SERVICE BULLETIN
NO:06011-R3

MODELS : TX-SR674 / TX-SR804 / DTR7.7

SUBJECT : Picture Interruption in output of 1080P signal via HDMI on Playstation 3

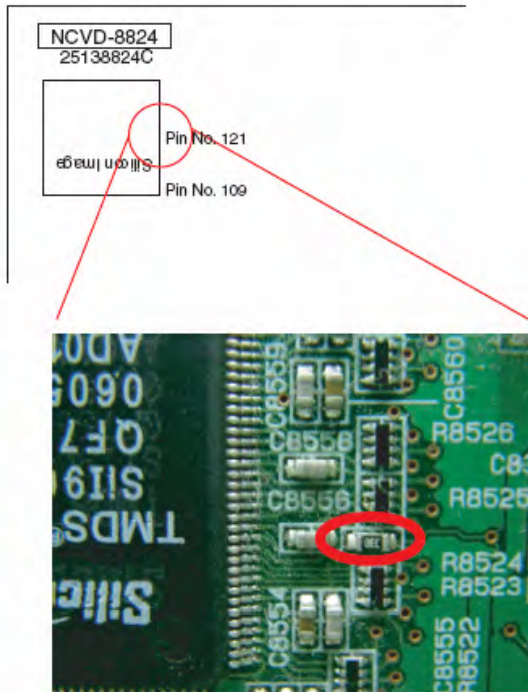
- 1) Remove Capacitor C8428 on HDMI Board NAVD-8824.
- 2) Change Resistor at R8524 from 33 ohm to 0ohm on HDMI Board NAVD-8824.

C8428 Remove this capacitor.

R8524 Change Resistance Value from 33ohm to 10ohm.

The resistance value of R8524 was changed to 22ohm first and then to 10ohm again. and finally to 0ohm . 0ohm is the best and 10ohm is better, but 10ohm and 22ohm are also effective. Therefore, when 22 or 10 ohm Resistor is mounted at R8524, it is not necessary to replace it by 0ohm Resistor as long as the unit has no problem.
